MEMORANDUM

SUBJECT: Holladay Properties Self Storage, P.C. #22-015, 401 W. Golf Rd.

PLAN COMMISSION PC #22-015
Holladay Properties Self Storage
401 W Golf Road
Round 1 (revised)

Round 1 Review Comments

VILLAGE OF ARLINGTON HEIGHTS WATER METER PIT SPECIFICATIONS

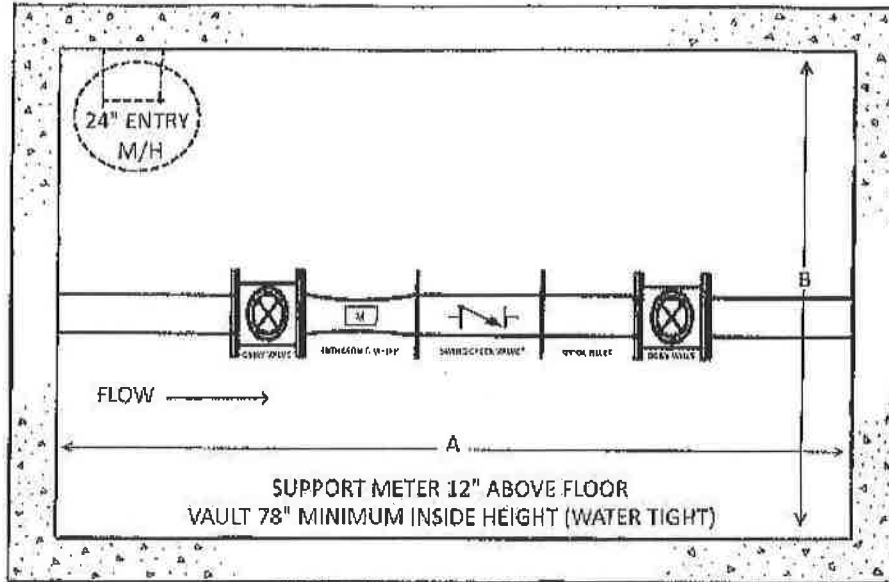
25. Provide the maintenance access points for the 60" underground detention system.
26. Provide an operation and maintenance plan for the stormwater detention.
27. The existing wells on the property must be properly capped.
28. A domestic water service line with RPZ is required.
29. Attached is a diagram that must be used for the fire line meter pit
